# Della Construction Co. Subdivision

Somers, Connecticut

Review Date: FEBRUARY 23, 1987

ENVIRONMENTAL REVIEW TEAM REPORT

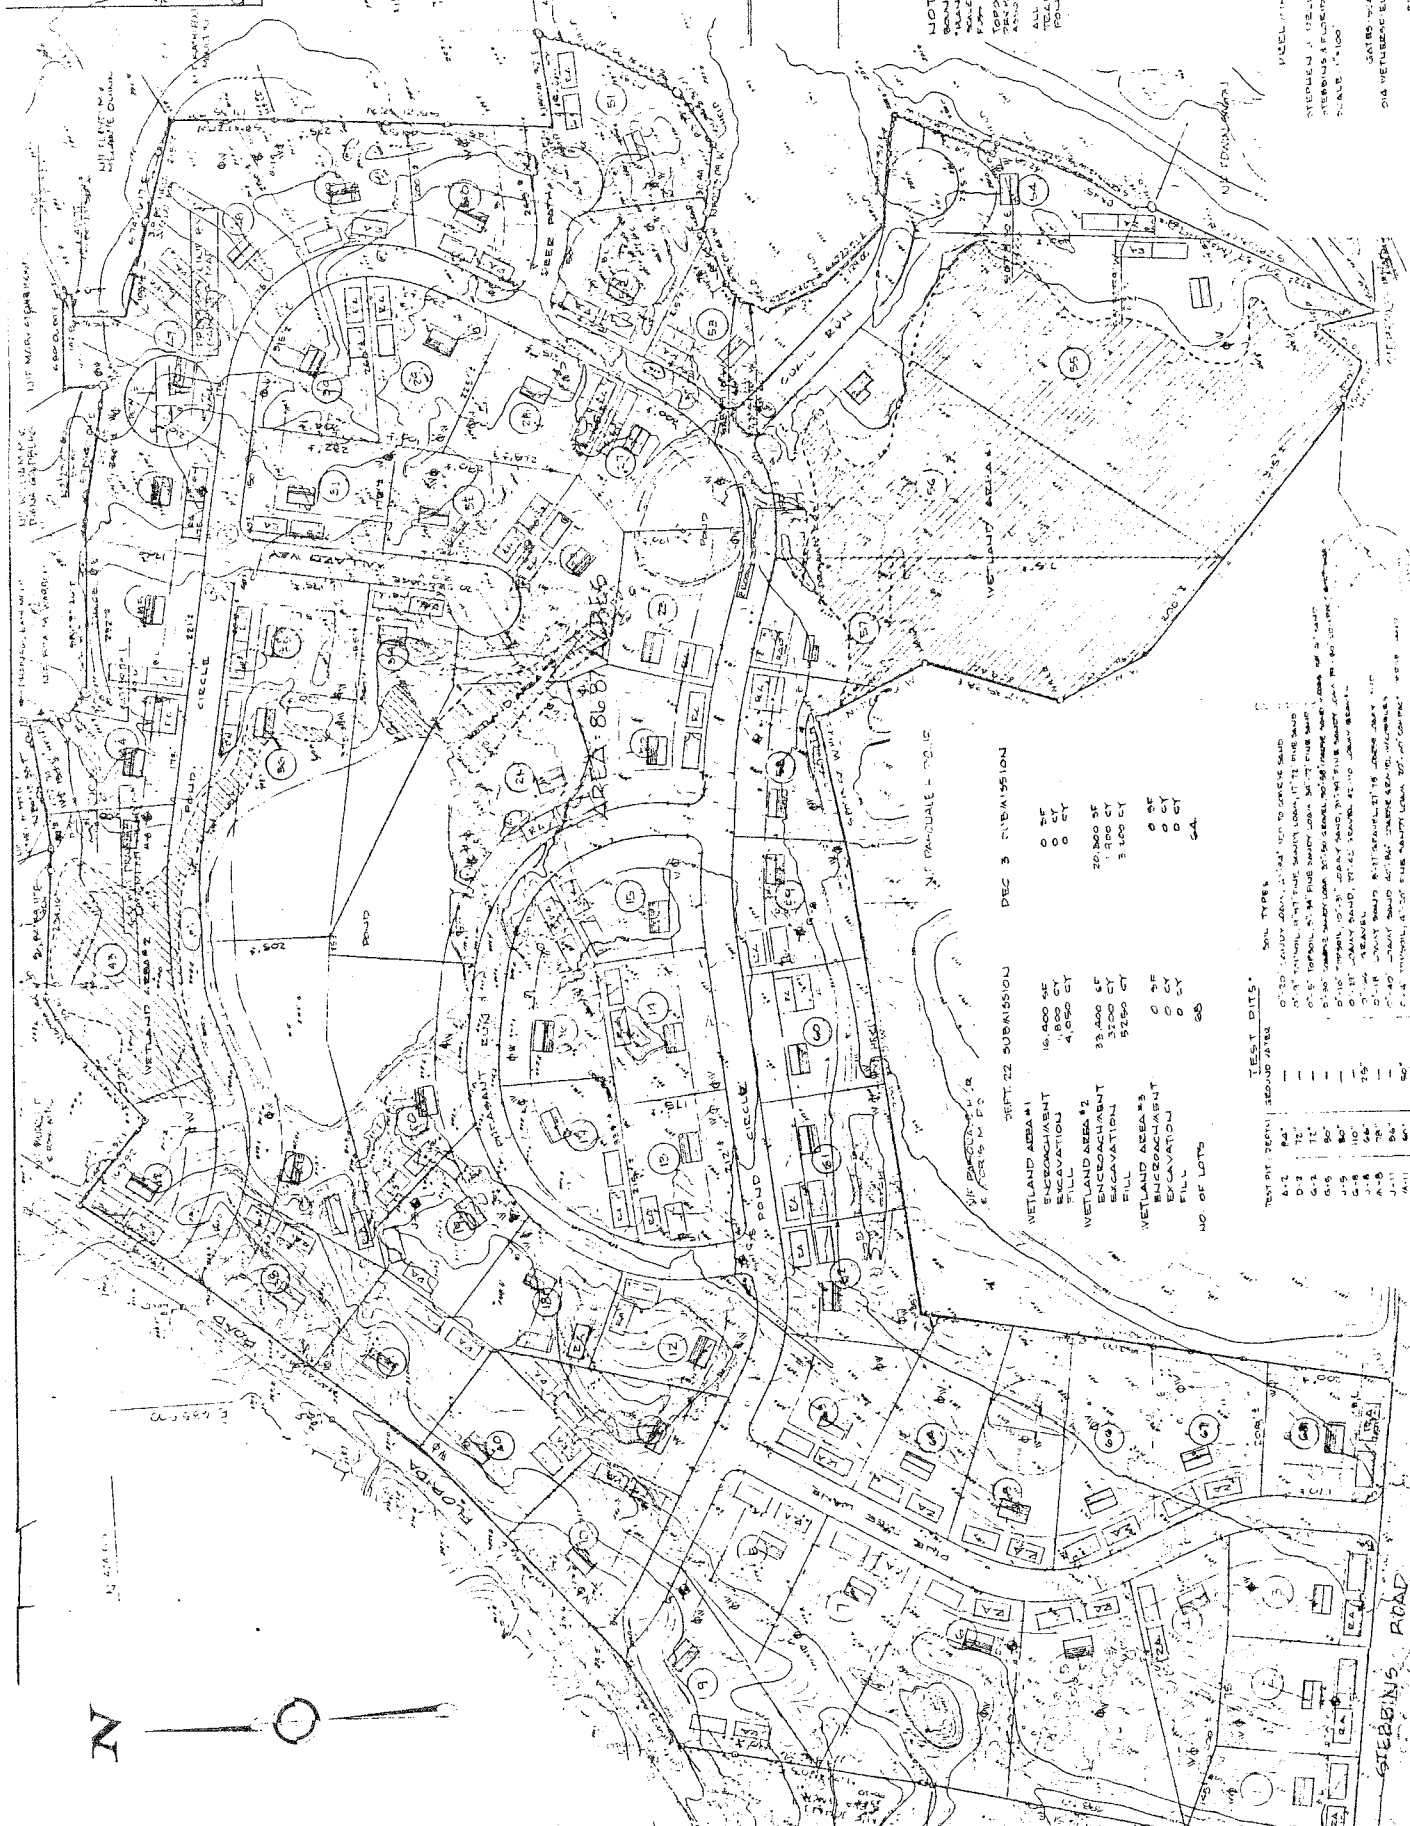
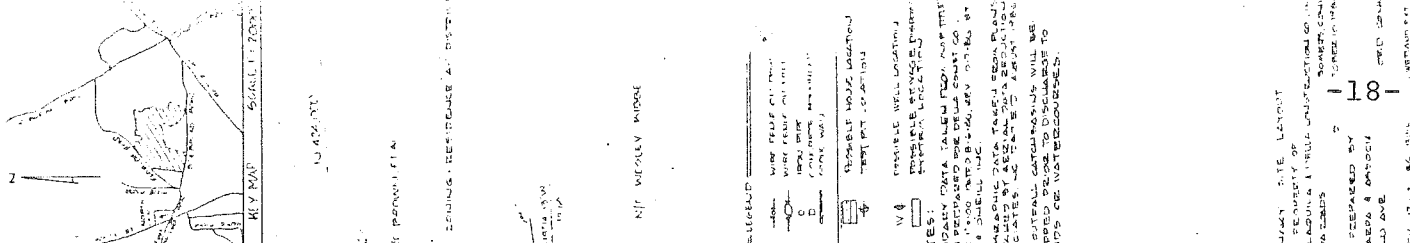
2. The extent of wetlands on the adjacent property (Kibbe) that abuts Lots 51, 53 and 54 as well as a watercourse should be on the plan map. The impacts of development on this wetland system should also be addressed.

3. Al Roberts, Soil Scientist, SCS, has examined the low area on Lots 57 and 58 and concluded that the area is a wetland. It should be shown as such on the plans.

5. The Town of Somers should consider requiring the developer to set aside the major wetlands, watercourses and ponds as open space. This would include large portions of Lots 24, 26, 27, 34, 36, 37, 43, 55, 56, and 58 as shown on the 10-28-86 revision. The result would be a pond, wetland and streambelt zone along the drainage way. This type of system would provide excellent wildlife habitat and recreational benefits to the Town. It would also minimize the degree of wetland encroachment. As currently proposed the development will result in extensive alteration of wetlands by either the developer or subsequent lot owners.

9. The dike and watercourse below the large wetland on Lots 56, 57 and 58 are in poor condition. Measures to improve these should be developed and shown on the plans.

Despite the fact that this subdivision is on the site of a recent excavation project, it has many unique topographic features of which the proposed subdivision does not take advantage. Neither the subdivider nor the Planning Commission are making demands of

The subdivider has drawn up a plan, which simply gives them as many lots as the site can offer. The Town does not appear to be making its desires known to the subdivider. The resultant plan does not do justice to the site.

Planner's Layout

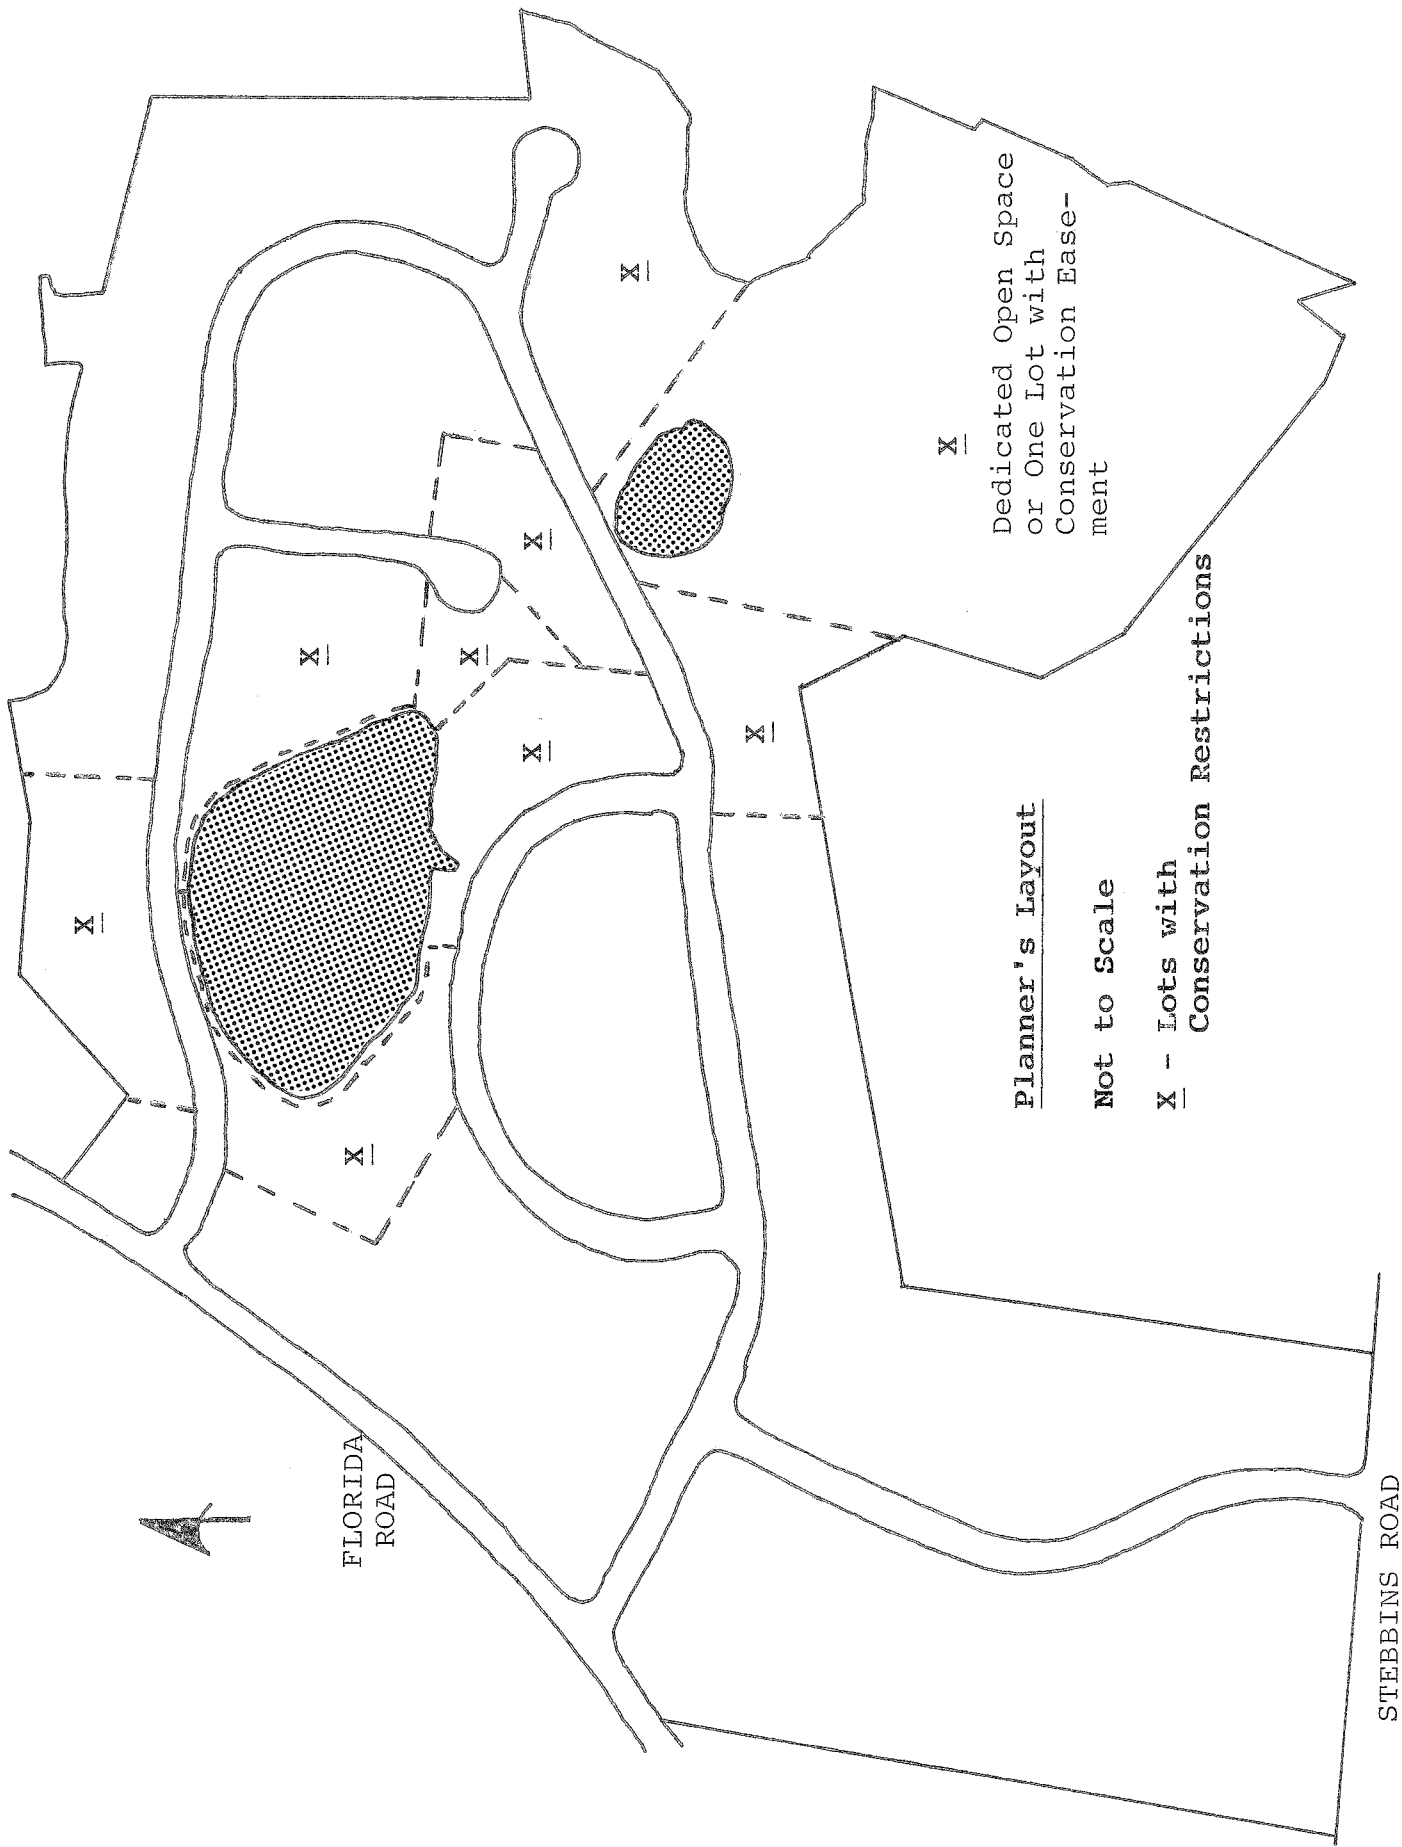
To demonstrate what could be a more attractive layout, the Team Planner has taken the liberty of making an overlay of the site to suggest what might increase the value of some of the lots and preserve some of the desirable wetlands. Although the total number of lots would be decreased, certain lots would be of a character that will appeal to individuals that have a sensitivity to the fragile nature of those sites. In turn this layout reduces the length of road the developer must build. This would be an ultimate savings to the developer.

As stated at the February 23rd meeting, the Planner feels that the ponds and the wetlands should remain in a single ownership because of the complex legal nature of any maintenance or dispute possible in the future.
